# HISTORIC AND DESIGN REVIEW COMMISSION

October 02, 2019

**HDRC CASE NO:** 2018-533  
**COMMON NAME:** 335 TRAIL  
**LEGAL DESCRIPTION:** NCB 6078 BLK 2 LOTS 9 THRU 14 & 17 THRU 20  
**ZONING:** MF-33, H, RIO  
**CITY COUNCIL DIST.:** 1  
**DISTRICT:** River Road Historic District  
**APPLICANT:** Katie Bingham, AIA/Mark Odom Studio  
**OWNER:** Robert Price  
**TYPE OF WORK:** Construction of a multi-family residential development  
**APPLICATION RECEIVED:** August 05, 2019  
**60-DAY REVIEW:** October 04, 2019  
**CASE MANAGER:** Edward Hall

## REQUEST:

PLAT NO. 19-11800095  
TRAIL STREET TOWNHOMES  
GRADING PLAN

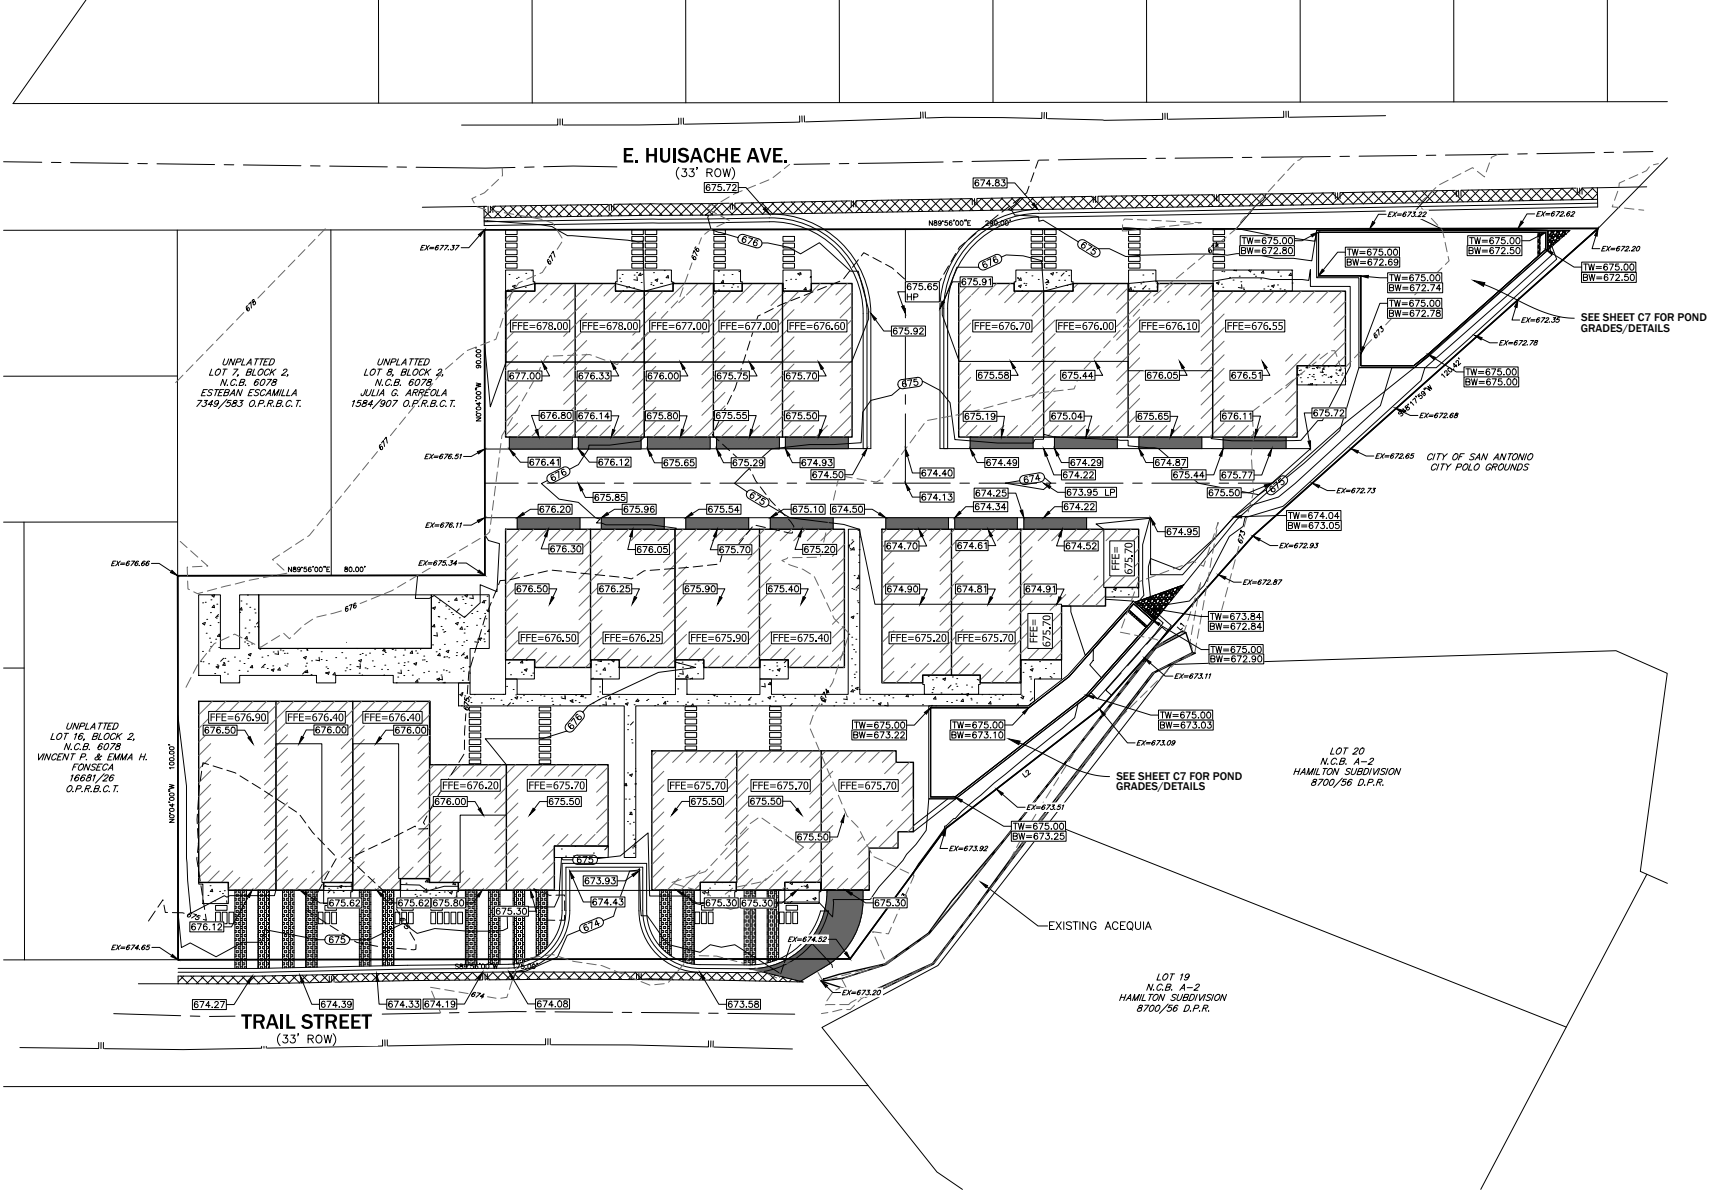
- ACEQUIA NOTES:
1. NO SUBSURFACE WORK (UTILITIES, GRADING, ETC.) SHALL BE ALLOWED WITHIN THREE FEET OF THE EXISTING ACEQUIA.
  2. CONTRACTOR SHALL INSTALL ORANGE CONSTRUCTION FENCING AND SILT FENCING AT A BUFFER DISTANCE OF 3 FEET FROM THE FEATURE.
  3. NO CONSTRUCTION ACTIVITIES WILL OCCUR WITHIN THE BUFFER AREA.
  4. THIS CONSTRUCTION AND SILT FENCING SHALL BE PRESENT ON-SITE UNTIL CONSTRUCTION IS COMPLETED.
  5. THE ACEQUIA SHALL NOT BE USED FOR STORM WATER DRAINAGE. FURTHERMORE, THE ACEQUIA SHALL NOT BE USED FOR STORAGE, EQUIPMENT CLEANING OF ANY OTHER USE THAT COULD IMPACT THE FEATURE.

DETENTION POND PLAN

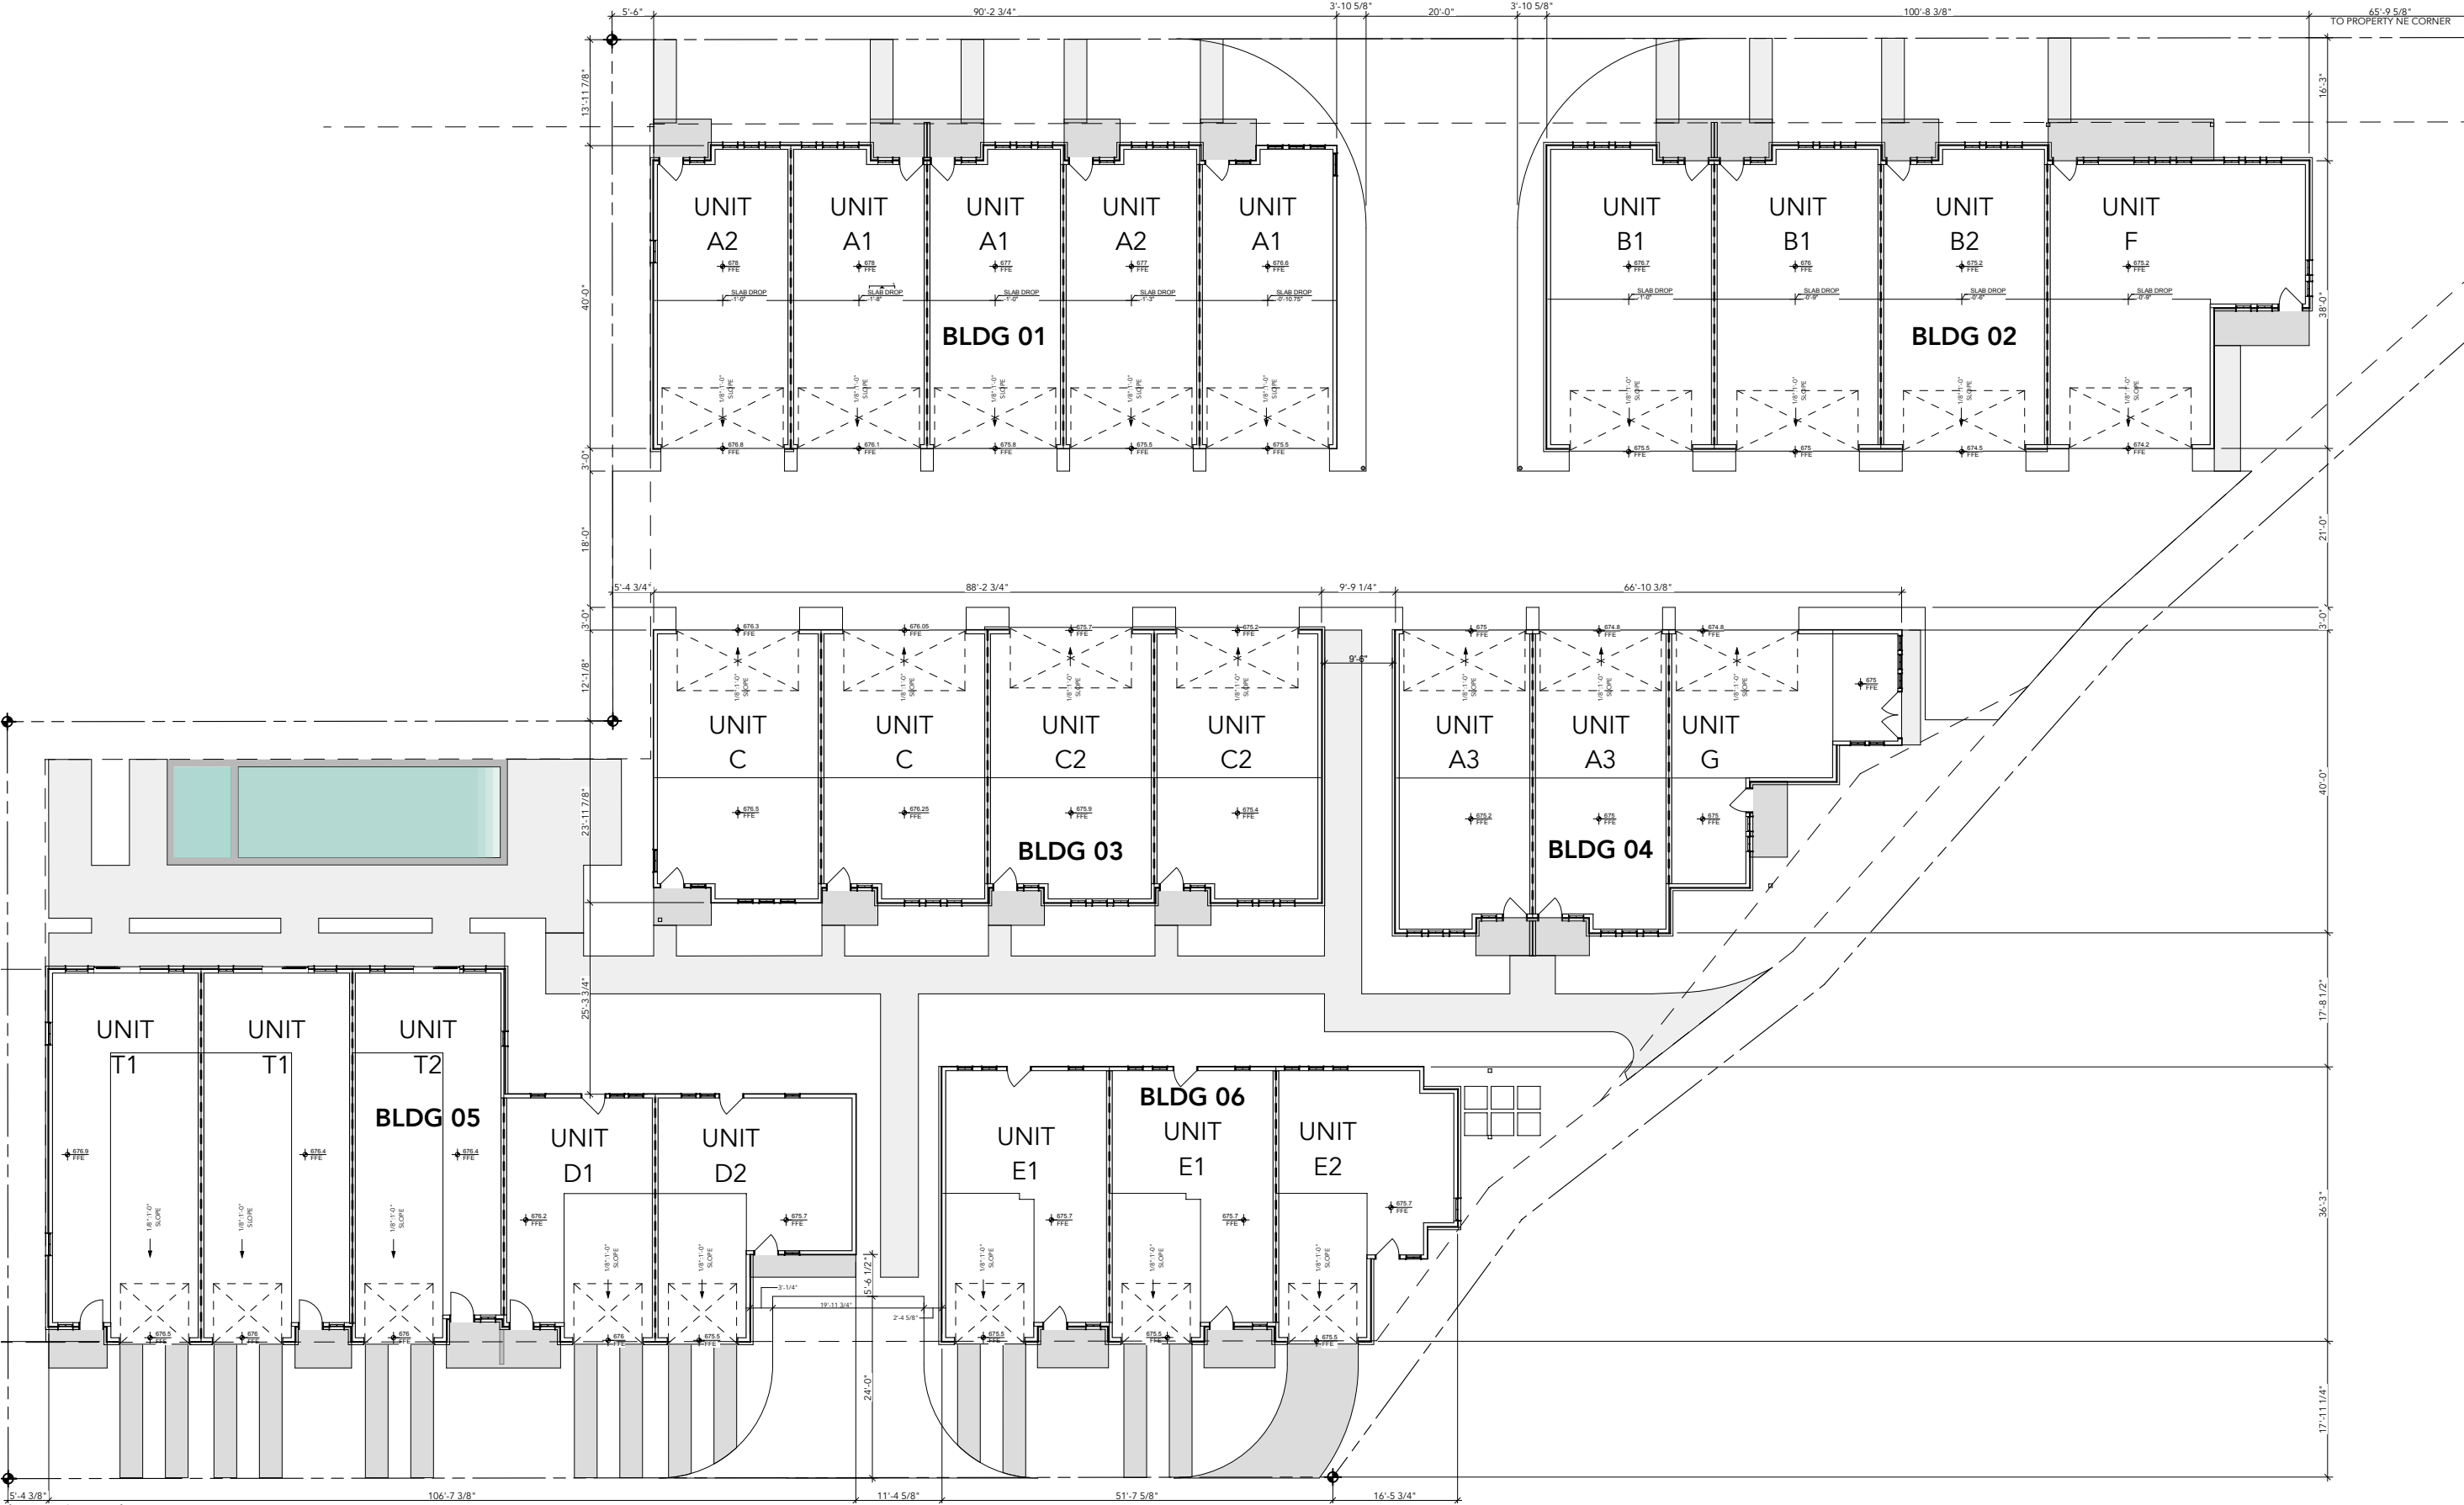
- x. **DRAINAGE** – The applicant has updated design documents to include a drainage plan, the location of detention ponds. The applicant has submitted two options; Option 1 includes two detention ponds with vertical walls. Pond 1 would discharge towards Huisache and pond 2 discharges toward the acequia. As previously noted by staff, using the historic acequia for drainage is not allowed per the UDC Section 35-671. Drainage Option 2 would include one detention pond at the north east corner of the property with vertical walls and permeable pavers in the shared drive.
